RFP Title: Trinity Square Area Water Main Rehabilitation

ADDENDUM NO. 3

RE: TRINITY SQUARE AREA WATER MAIN REHABILITATION
CONTRACT NO. 8-23

AREA PLAN 7
 PROJECT NO. 1516-274596
 FILE NAME: C001PLPR.DWG
 SHEET NO. C-7

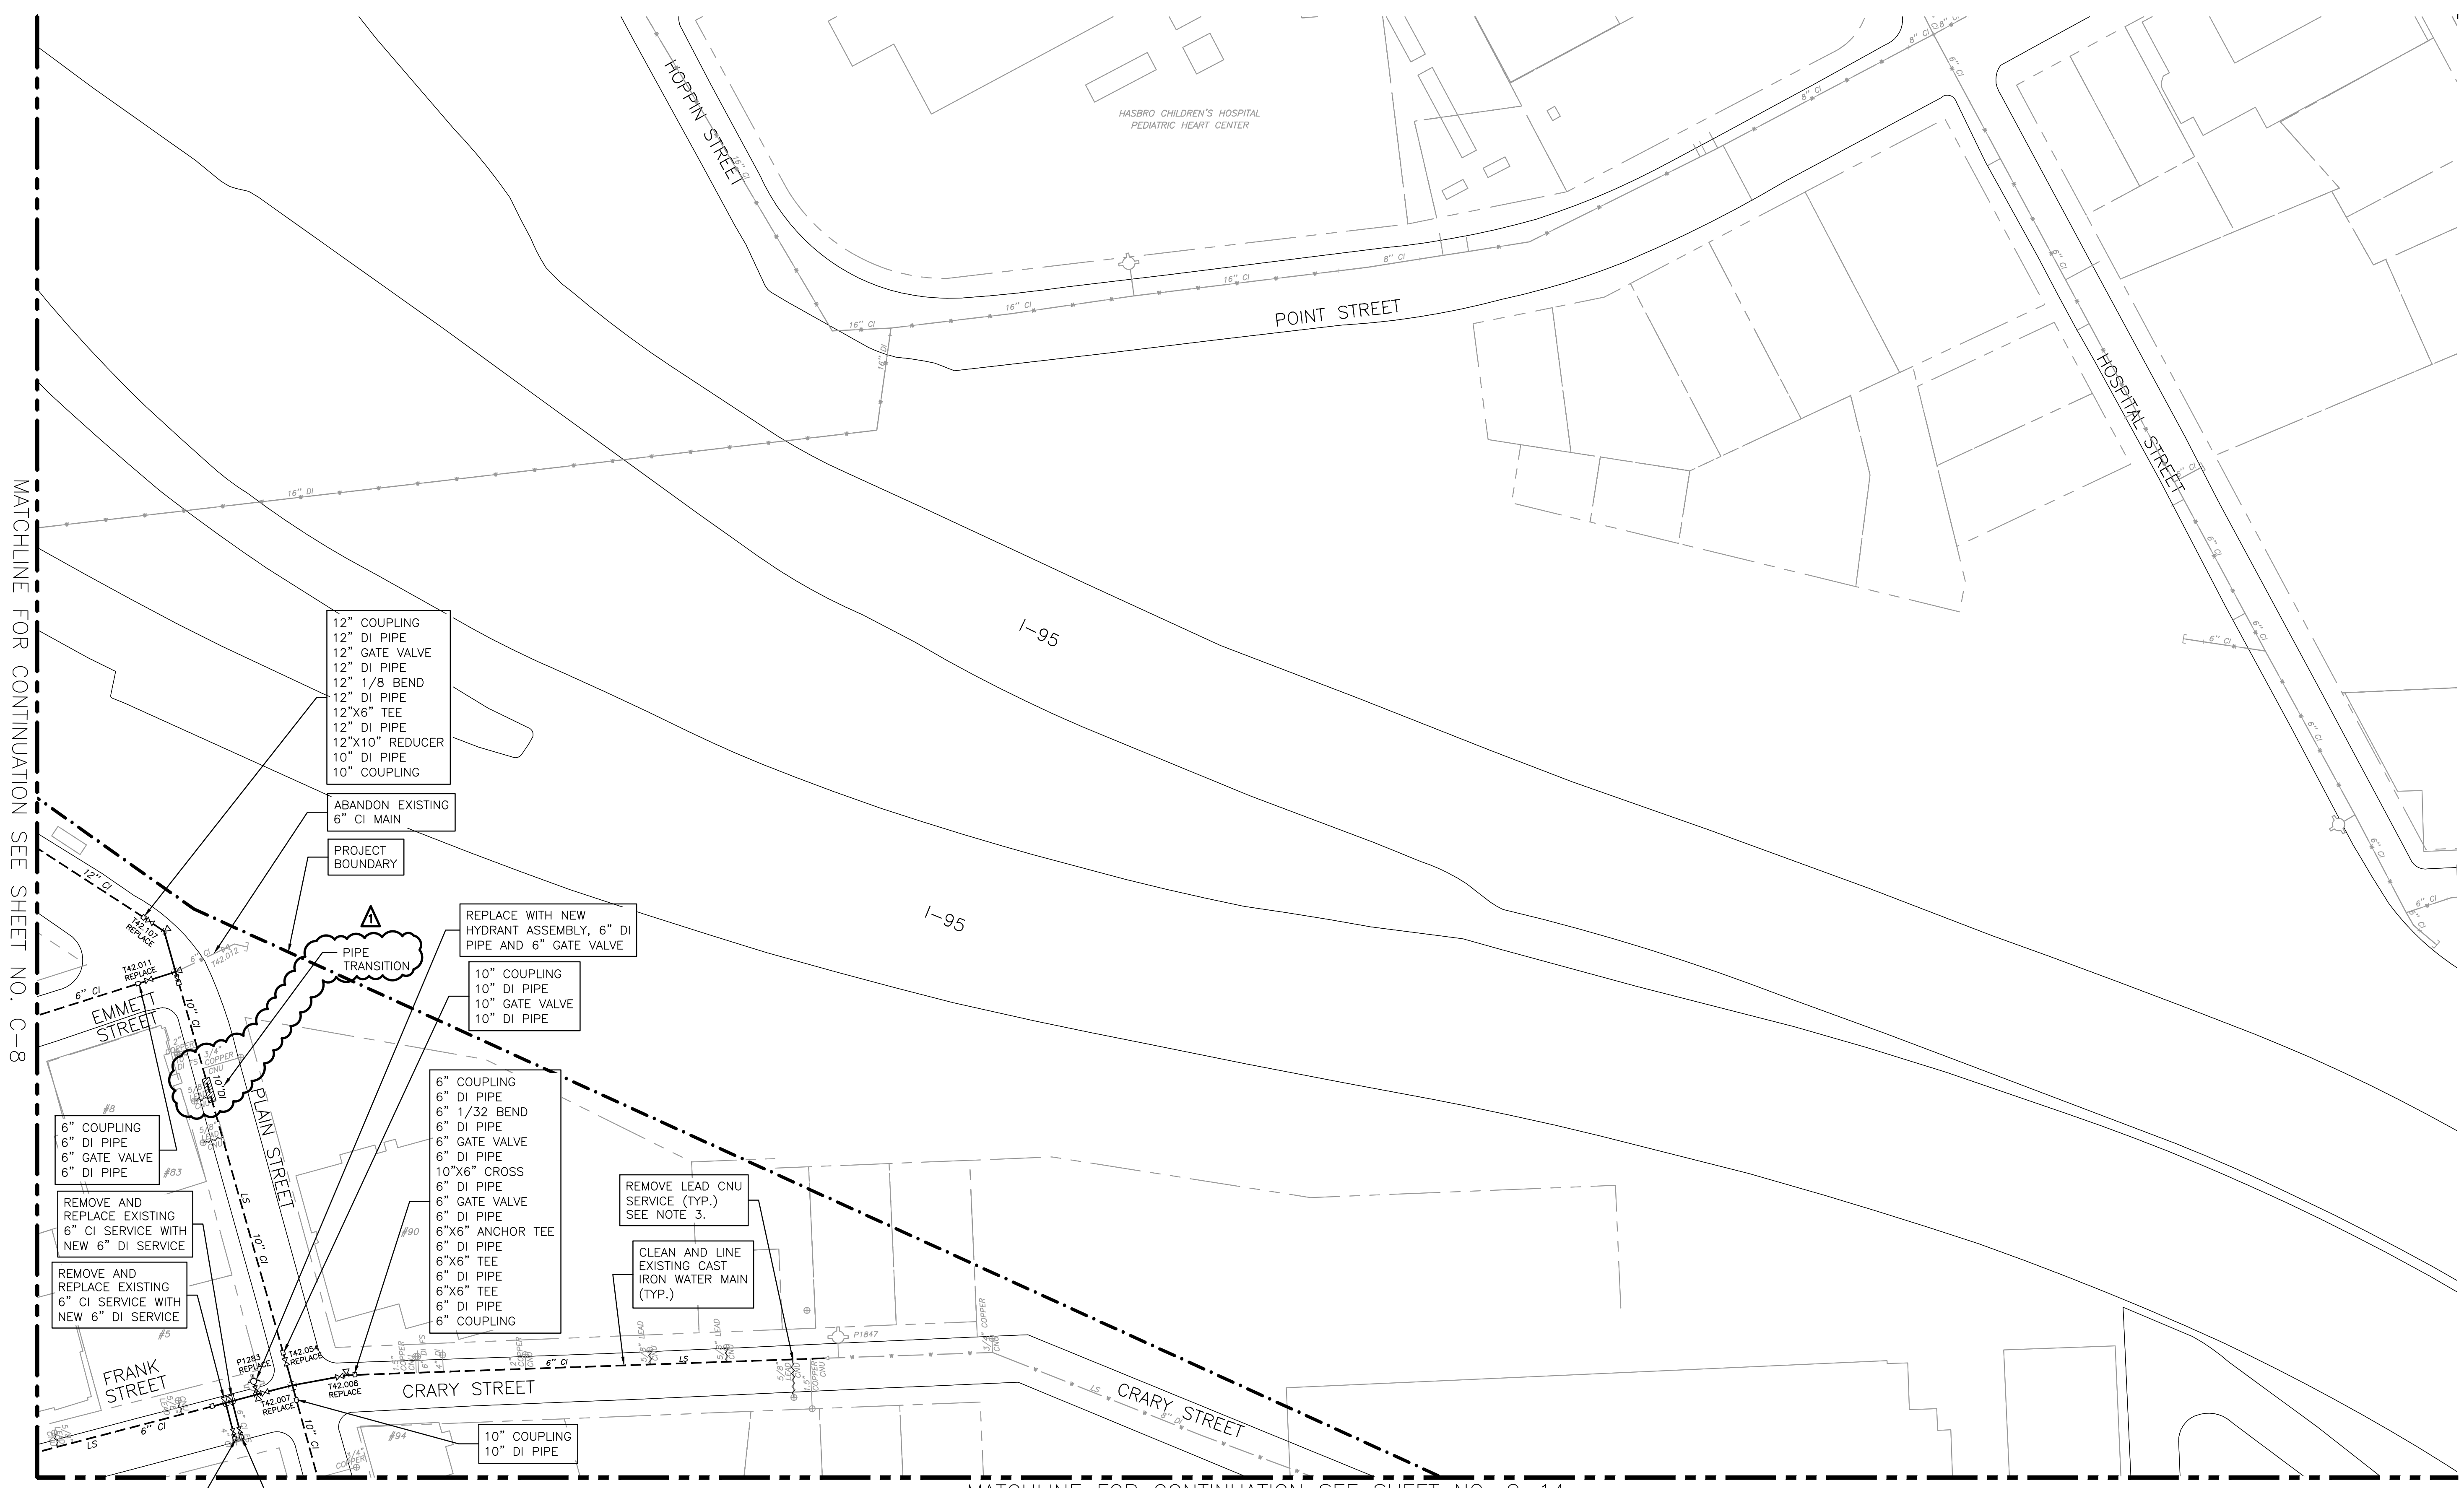
14. QUESTION: There are several locations that call for removal of 30 inch tees for sidelines, and installation of 30 inch tees for hydrants (C-1 & C-7), but the bid items only pay for 6, 8, 10, and 12 inch Ductile Iron pipe. There is no item for 16, 20, or 30 inch Ductile Iron Pipe. Please clarify how the contractor is to be reimbursed for the work to install these short segments.

RESPONSE: Please see Response to Question 3.

PROJECT NO. 1516-274596
 FILE NAME: C001PLPR.DWG
 SHEET NO. **C-9**

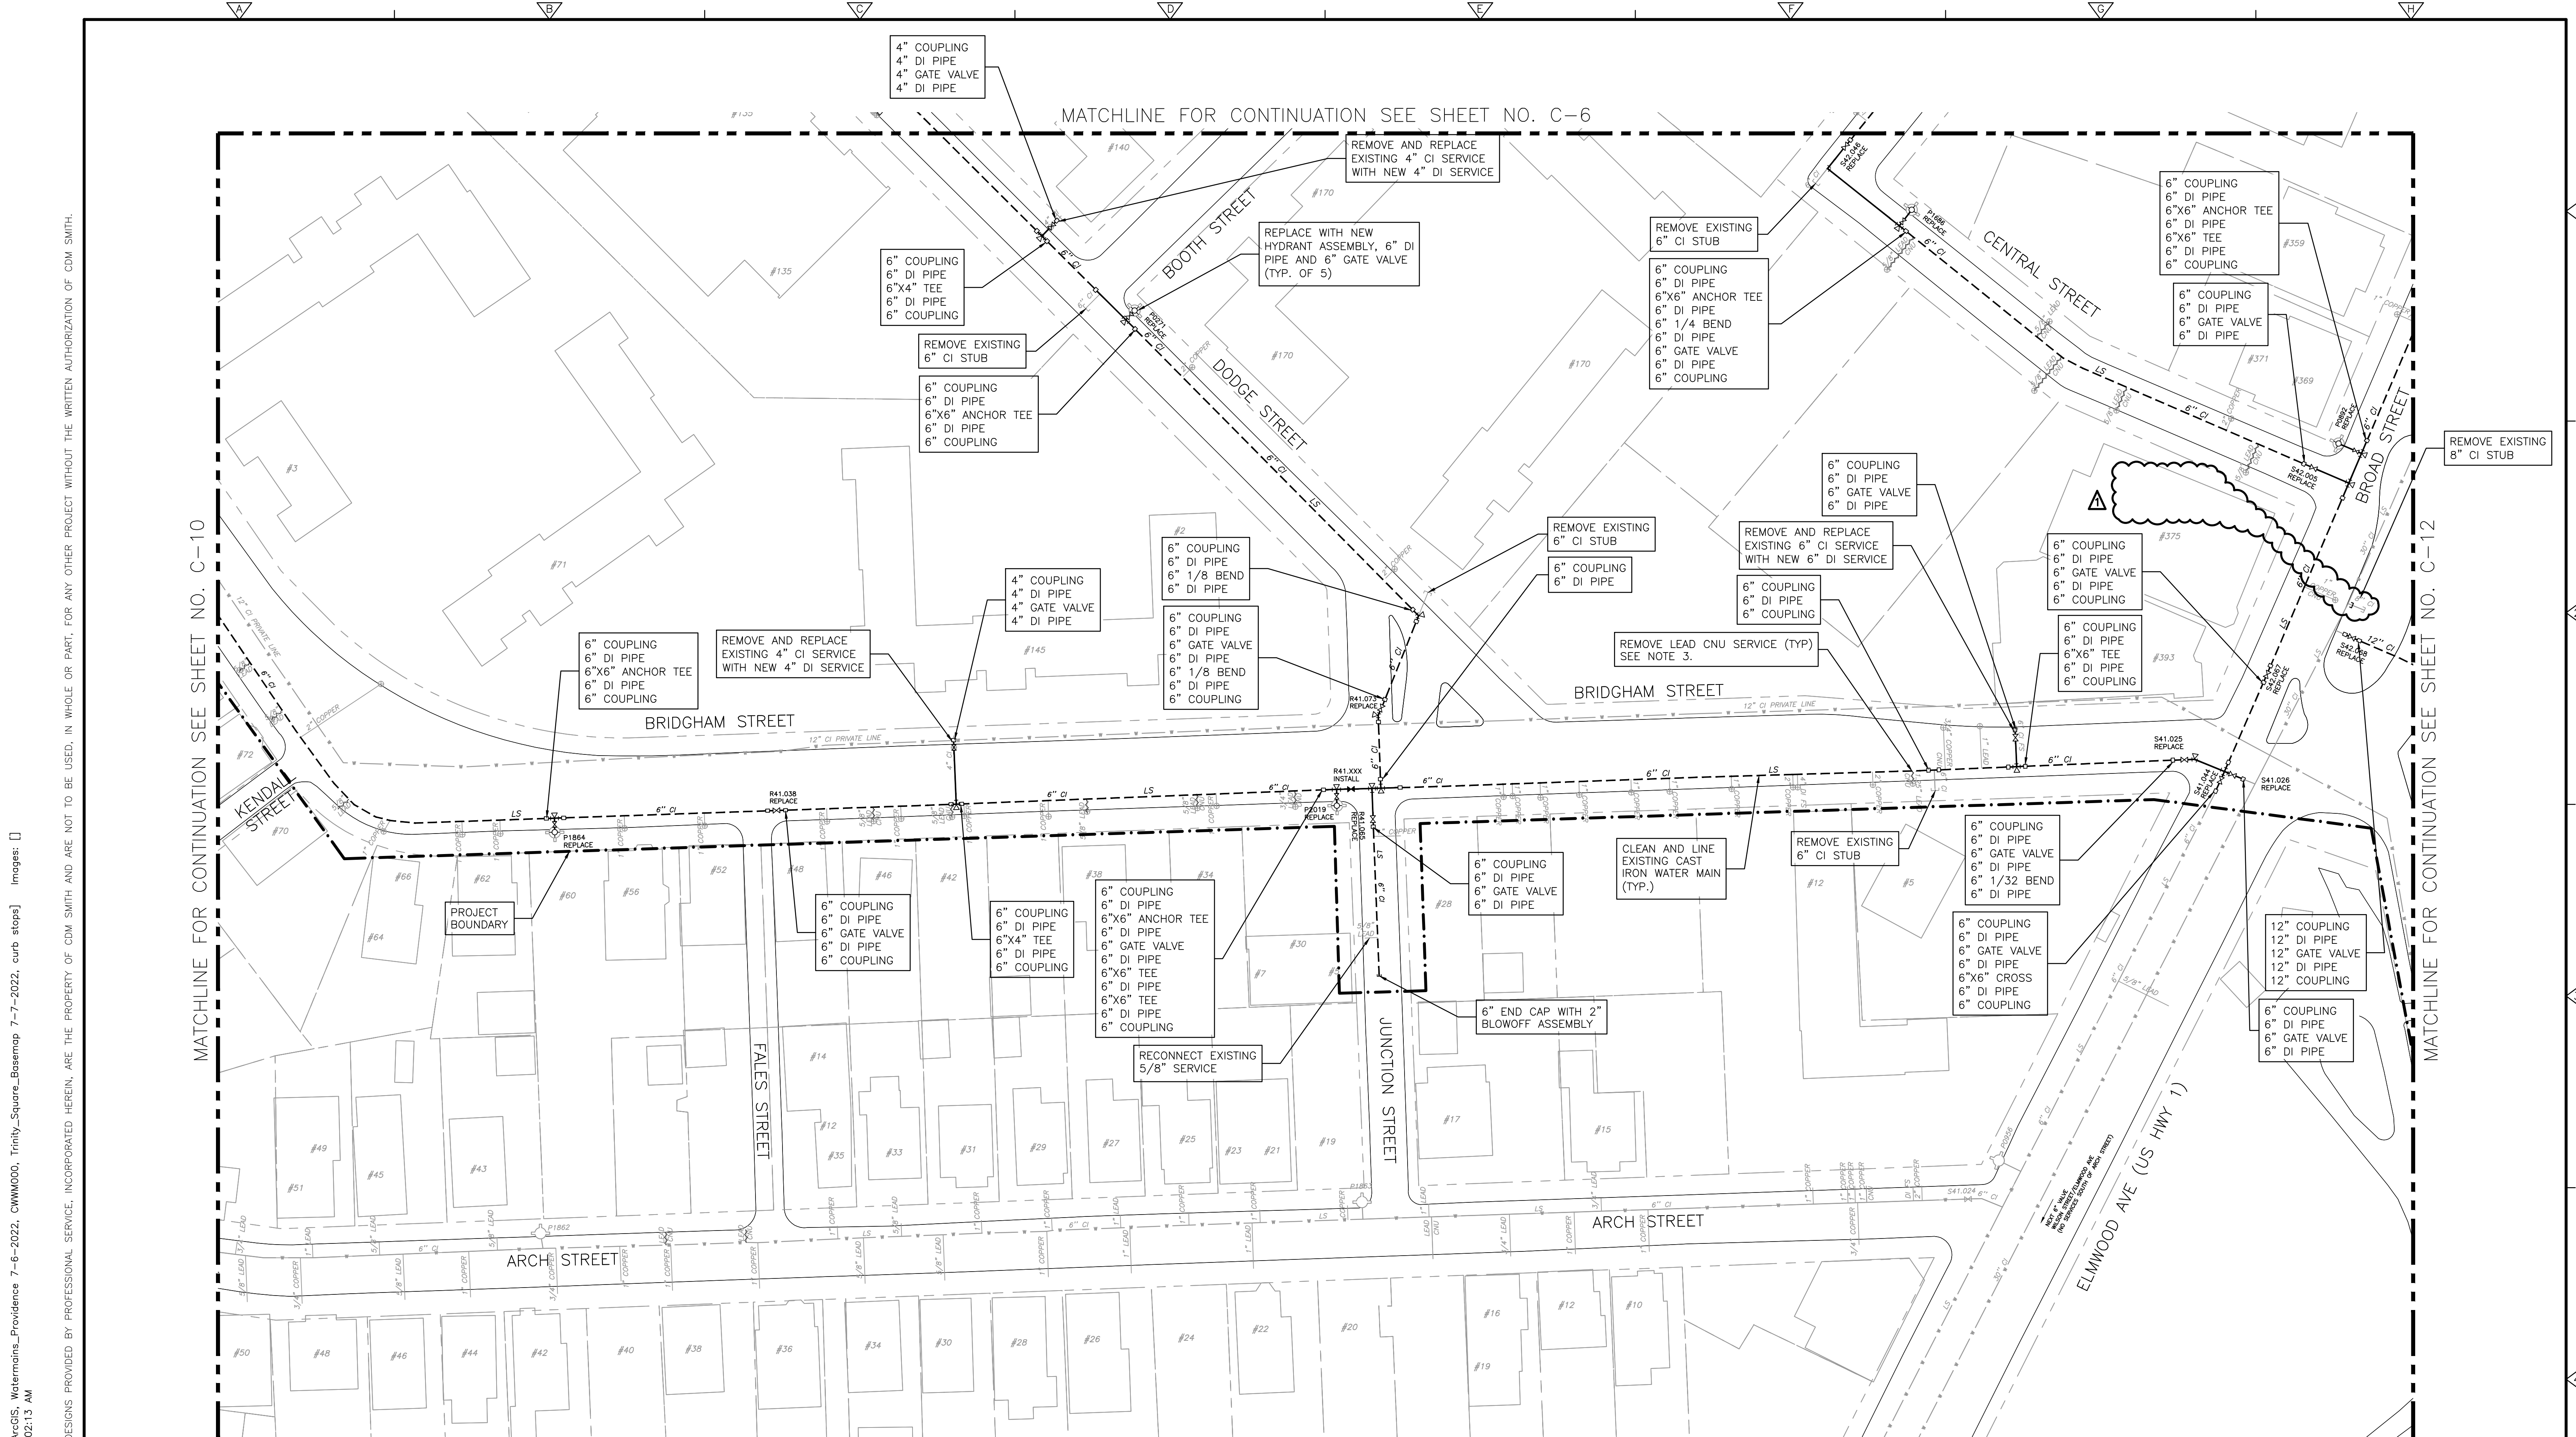
15. QUESTION: On Plain Street (sheet C-9 and C-14) there are several items that need clarification.

a. On sheet C-9, the 10 inch main from Emmett St to Frank St is labeled as CI, then as DI, and again as CI. Is this a typographical error? If there is a transition from cast, to ductile, and back to cast, are the extents known? Or will the contractor be responsible to determine the limits of Cleaning and lining of the Cast iron segments?

b. On Plain Street the Main transitions from 10 inch at Frank to 12 inch at Oldham / Borden intersection. Is there in fact a reducer along that extent? Is the location known, or is the contractor responsible for determining the location?

- c. At the intersection of the main on Plain Street with the 20 inch Main on Oldham, is the 20 inch being connected to the 12 inch (or 10 inch) and the 6 inch on Oldham? The work callouts do not show a 20 inch cross, or tees being installed. Please clarify exactly what is happening in this intersection.

RESPONSE: See the Contract Drawings in Attachment No. 3 of this Addendum.

RESPONSE: See the Contract Drawings in Attachment No. 3 of this Addendum.

RESPONSE: This work was revised. See the attached updated Contract Drawing sheets.
